产品开发更改

DC No. / 开发更改编号: PDECR_0053

Customer project Name/ 客户项目名称:	57cc e-compressor	MCR No. / MCR号:	NA
Affect Product No. / 产品		Component No./ 零部件号:	
57cc e-compressor F01Z 7P0 013-04 CNHTC 57cc e-compressor F01Z 7P0 00H-01 XCMG 57cc e-compressor F01Z 7P0 012-04 Geely FD 57cc e-compressor F01Z 7P0 012 Geely SOP 57cc e-compressor F01Z 7P0 014-02 Qingling H47 45cc e-compressor F01Z 7P0 01E-01 Qingling 4.5T BEV		Offerdrawing: F01Z7D0013-01 F01Z7D000H-01 F01Z7D0012-01 F01Z7D0012 F01Z7D0014-01 F01Z7D001E-01	EOL function PMB: F01Z7S0003 F01Z7S0003-01
Sample type / 样品类型:	☐ A ☐ B ☐ C ☒ FD	Initiator/发起人:	ZHU Qiangmin(RBCD/EIS3)

充氮压力试验 不同压力下保护帽弹开状态确认

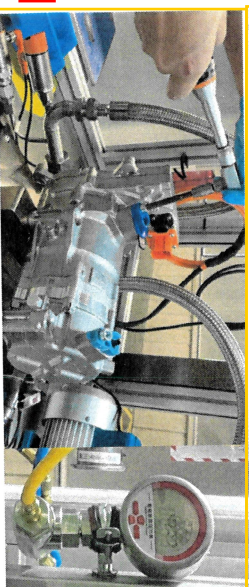
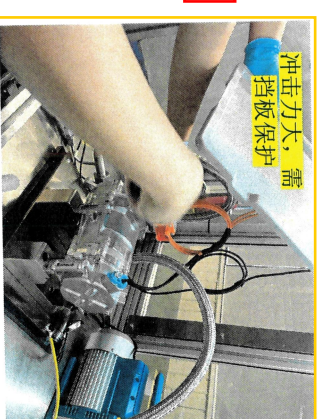
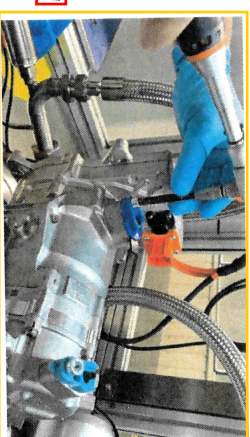
► **Background:** 产线和质量部反馈当前设定压力过高，在拆保护帽时，保护帽冲击力较大。

► 基于不同压力下的试验结果，决定降低充氮压力: 0.15MPaA~0.25MPaA → 0.13MPaA~0.19MPaA。

0.112MPaA

拆保护帽时无明显压力释放声，只在拔出时有“呲”声

0.13MPaA

拆保护帽时能听到压力释放声，且冲击力很小

0.15MPaA

拆保护帽时能听到压力释放声，冲击力不大
Internal C-SC11 RBCDERS
© Bosch Powertrain System

0.19MPaA

拆保护帽时能听到压力释放声，冲击力不大

0.25MPaA

结果: 压力在0.13MPaA~0.19MPaA之间，能够在拧松保护帽过程中感受到压缩机内正压力，并且其冲击力也不大。

eCOMP气测台架进口温度 台架进口温度传感器记录数据

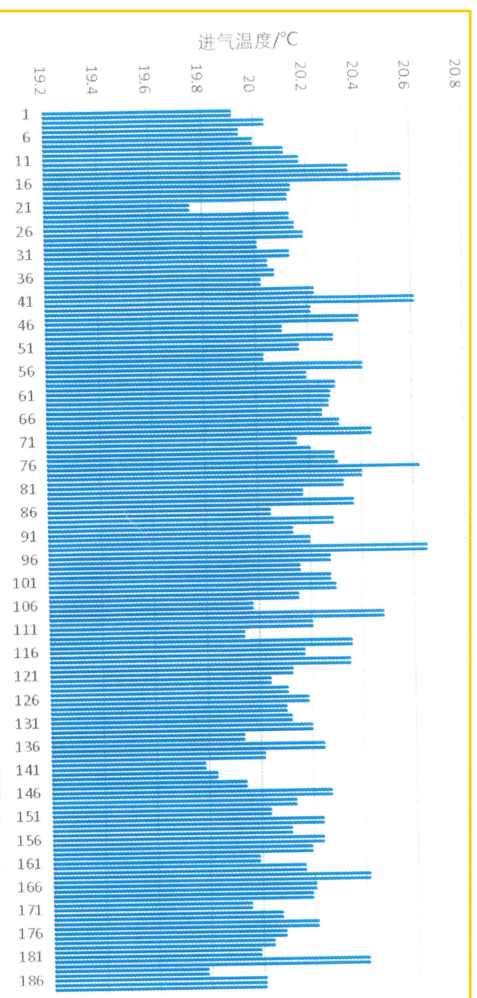
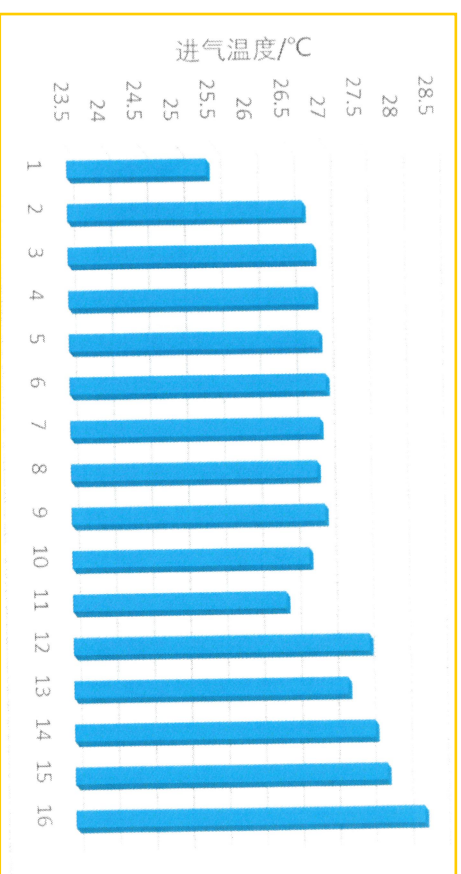
▶ 下线气测PMB中进气温度定义范围： $24.0\pm 3^{\circ}\text{C}$ 。由规范定义初期为数不多的几台压缩机数据确定了初始值。测试压缩空气由FCM集中供气，空气温度受季节影响较大，当前气测台架只有气体干燥作用，无控温作用。基于过去将近一年的实际生产数据，调整进气温度设定至 $25.0\pm 6^{\circ}\text{C}$ ，对压缩机下线功能检查无影响。

压缩机内部压力泄露试验

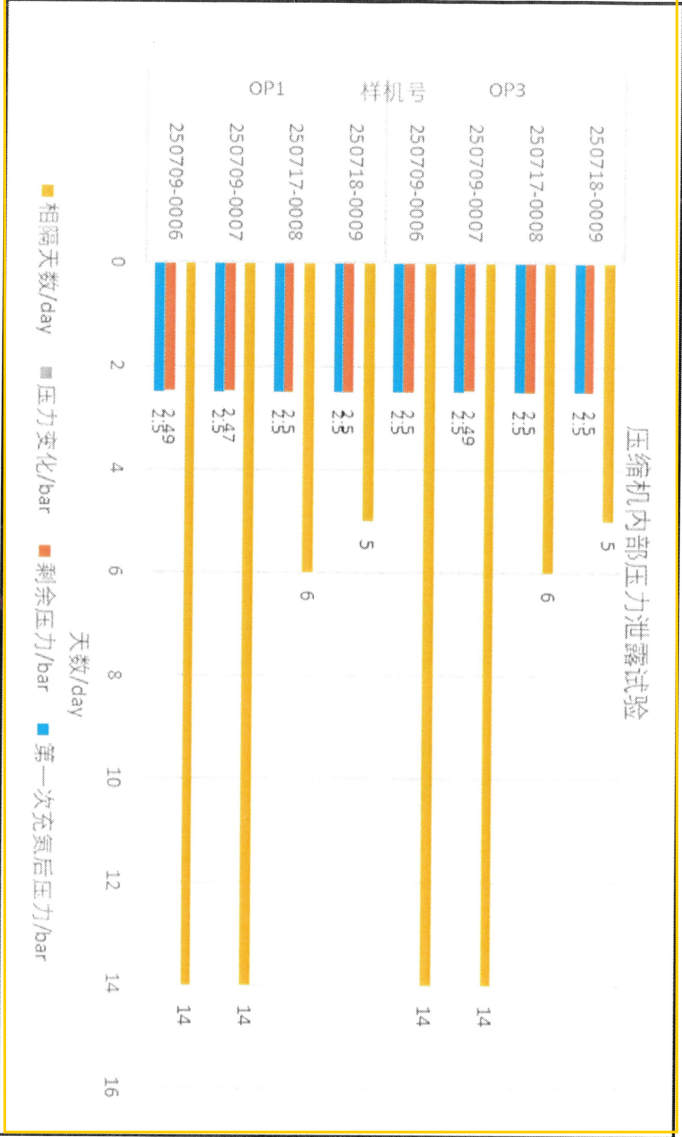
结果: 压缩机内部2.5bar压力下半个月几乎无泄露, 说明当前保护帽装配状态下内部压力保压能力良好。

理论上若压力小于2.5bar, 泄露率会更低。
